REFERENCE:	TSB: 11-002-25 REV. A GROUP: 11 - Exhaust System	Date:	October 8, 2025	REVISION:	11-002-25
VEHICLES AFFECTED:	2025 (WL) Jeep Grand Cherokee This bulletin applies to vehicles built on or after **June 25, 2025 (MDH 0625XX)** and on or before July 25, 2025 (MDH 0725XX) equipped with one of the following engines: <ul style="list-style-type: none"> • 3.6L V6 24V VVT Engine (Sales Code ERB). • 3.6L V6 24V VVT Engine Upg I w/ESS (Sales Code ERC). • 3.6L V6 24V VVT Engine (Sales Code ERF). • 3.6L V6 24V VVT eTorque Engine Upg I (Sales Code ERG). 			MARKET APPLICABILITY: <input checked="" type="checkbox"/> NA <input type="checkbox"/> MEA <input type="checkbox"/> SA <input type="checkbox"/> IAP <input type="checkbox"/> EE <input type="checkbox"/> CH NOTE: This bulletin applies to the North America market.	
CUSTOMER SYMPTOM:	Customers may experience the following: <ul style="list-style-type: none"> • Exhaust rattle going over bumps and on rough roads.

CAUSE:	Loose/missing muffler hanger fastener(s)

Fig. 1
Muffler Hanger Fasteners

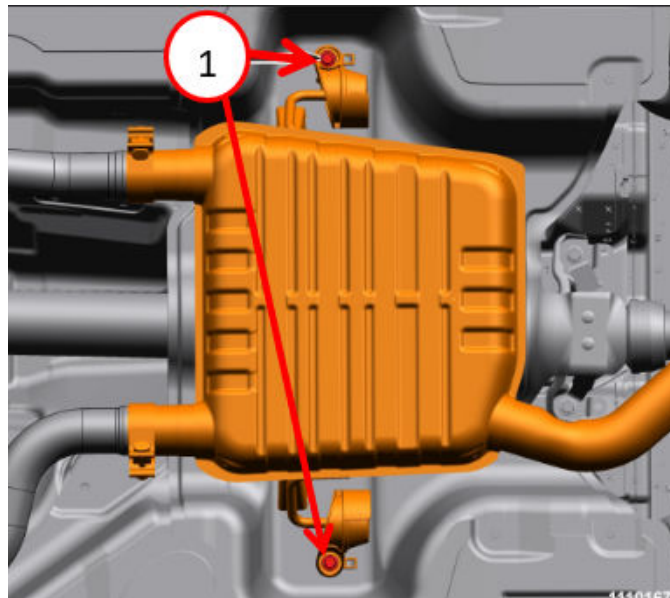
1. Raise and support the vehicle. Refer to the detailed service procedures available in DealerCONNECT/ Service Library under: 04 - Vehicle Quick Reference / Hoisting / Standard Procedure.
2. Inspect the muffler hanger fasteners [Fig. 1](#).

3. Are the muffler hanger fastener(s) loose/missing?
 - YES>>> Proceed to [Step 4](#).
 - NO>>> This bulletin has been completed, lower the vehicle. Use Inspect LOP (11-40-10-99) to close this active RSU. Perform further diagnosis.
4. Tighten the fasteners to 25 ft. lbs. (33 N·m). If fasteners are missing, install new fasteners and tighten to 25 ft. lbs. (33 N·m).
5. Lower the vehicle.
